Re: **Monte Viejo - Major Amendment**

MDP # 723D

The Development Review Committee has evaluated the **Monte Viejo – Major Amendment** Master Development Plan, or **MDP # 723D**. Enclosed is an accepted and signed copy of the MDP for your files. However, please note the following conditions:

**MAJOR AMENDMENT
 MONTE VIEJO MDP #723 D
 S.E. MILITARY DR. & I.H. 37
 MASTER DEVELOPMENT PLAN**

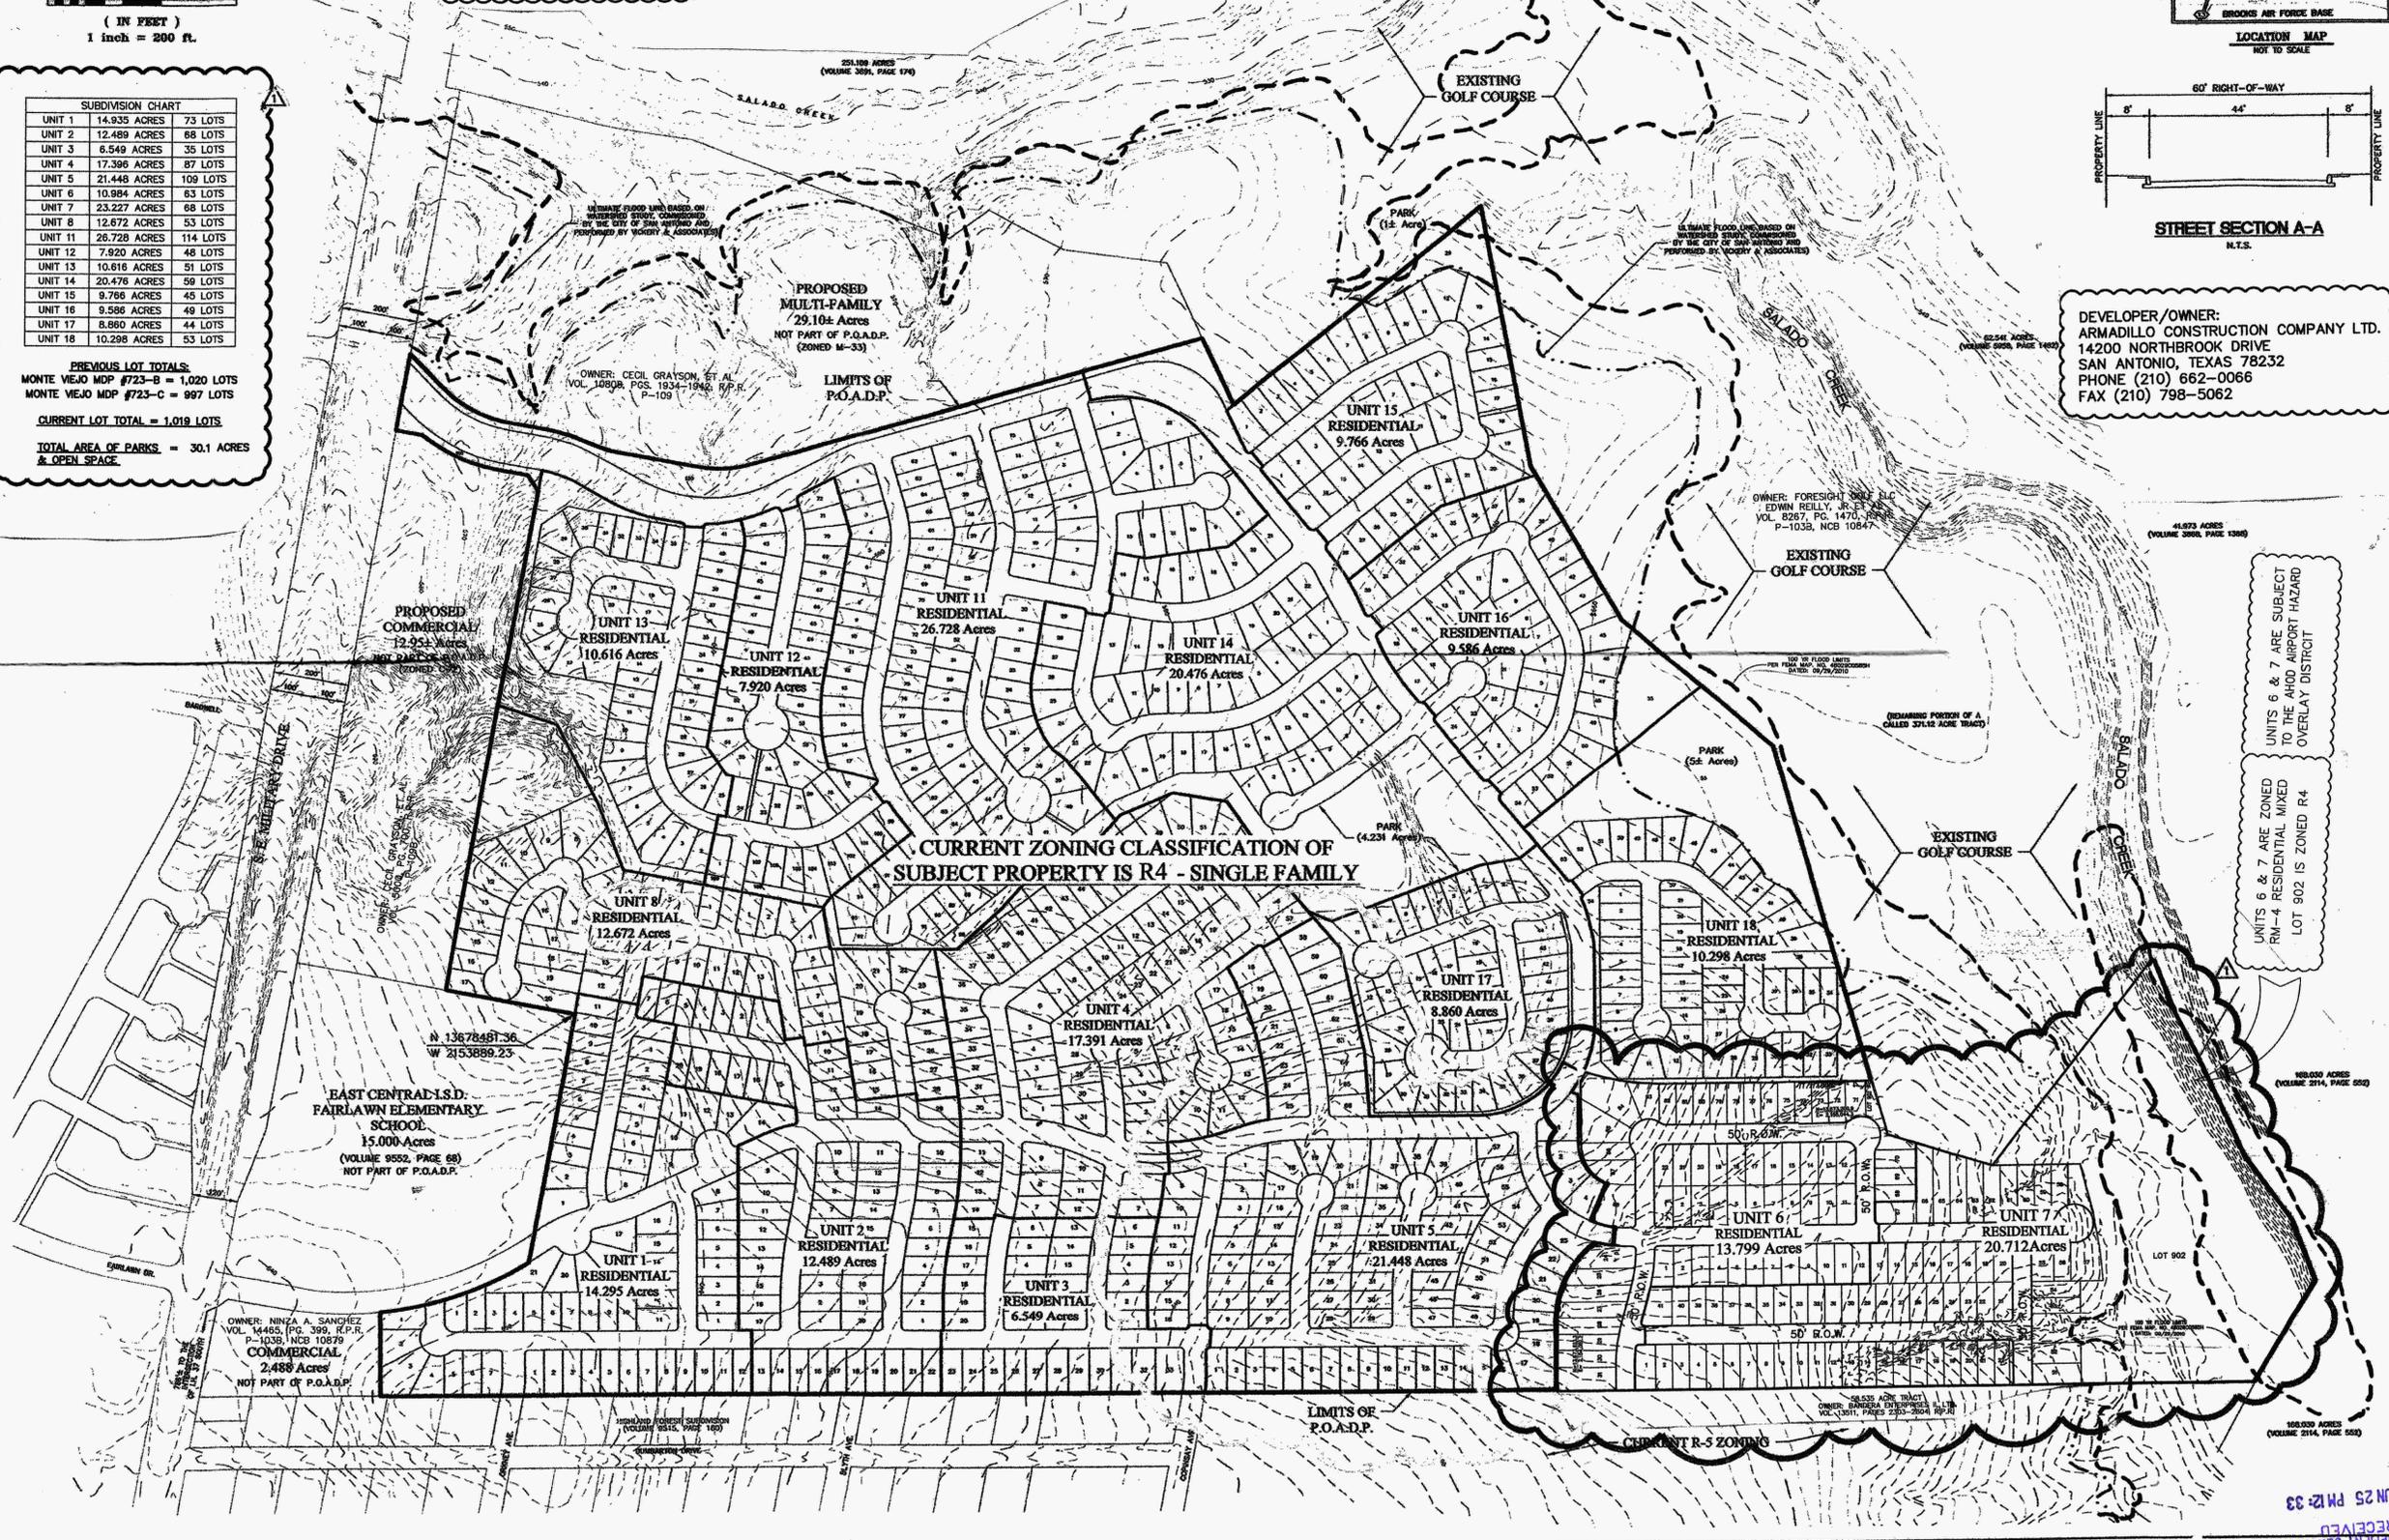
It will be expected that all of the property depicted in the Master Development Plan including but not limited to floodplains, drainage areas, and open space shall be platted. All platting shall comply with the Unified Development Code (UDC), the City's Master Plan, Major Thoroughfare Plan, and all applicable regulations for the City of San Antonio.

Please note that this action by the committee does not establish any commitment or support for the provision of drainage, utilities, services, or zoning of any type now or in the future by the City of San Antonio. In addition, it is suggested to work closely with the School Districts, so they can plan for the development accordingly.

In addition, the original MDP was approved prior to the change in regulation requiring the submission of a site plan for Lots with an RM zoning district designation for 10 lots or more; therefore, this requirement will not be required for Units 6 and 7 of this development, as they are the last two units to be completed.
